HLWYM HEmails

From: David Pickett
Sent: Tuesday, May 10, 2005 4:41 PM
To: Murphy, William
Subject: RE: questions attached
Attachments: Uth age map.pdf

Figure 4. Map of Nopal I uranium deposit with ^{230}Th - ^{234}U - ^{238}U model ages in thousands of years. "S.E." indicates secular equilibrium within uncertainty.

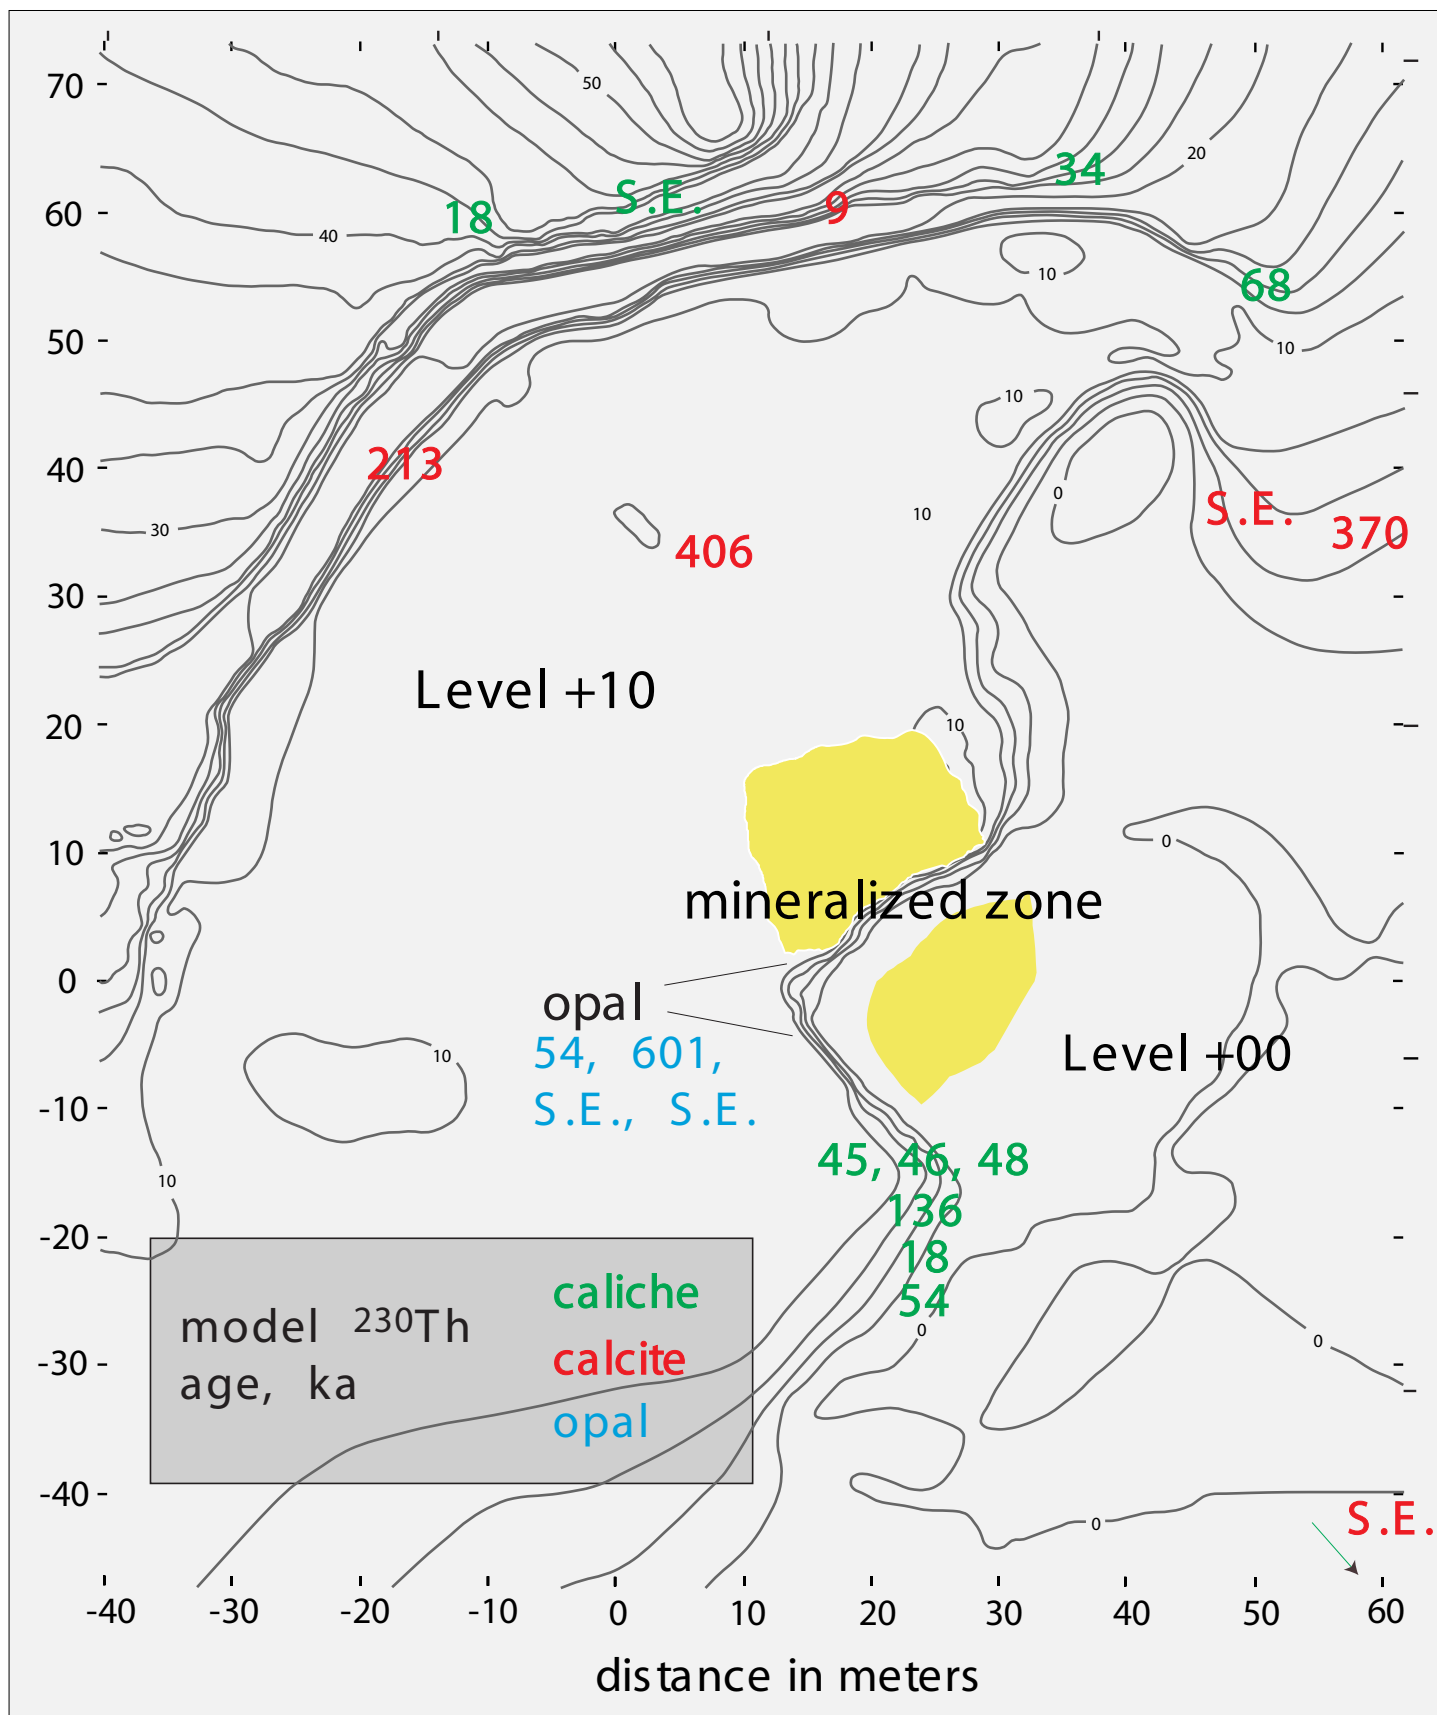
- I'll trust your judgment vis-a-vis thermo data, but we should talk.
- Caliche ages are Th-230. Amending the figure to say "Opal and Calcite (20-130 ka)" would be more or less appropriate. What is notable about the caliche ages is that, in almost all cases, the carbonate and non-carbonate fractions have similar ages. XRD says the non-carb is quartz - my XRD knowledge is limited, but doesn't this mean there could be other silica phases?
- Attached is the map of caliche, calcite, and opal ^{230}Th - ^{234}U - ^{238}U ages.
- In the $^{234}\text{U}/^{238}\text{U}$ vs U plot, "carbonates" means calcite and caliche.
- Prior to 8000 y, I-129 and Tc-99 dominate the dose. Yes, 18 km. "Groundwater" dose is from consuming water - but it may also include irrigated plants and dust from irrigated soil. I'm not absolutely sure. But no volcanism.
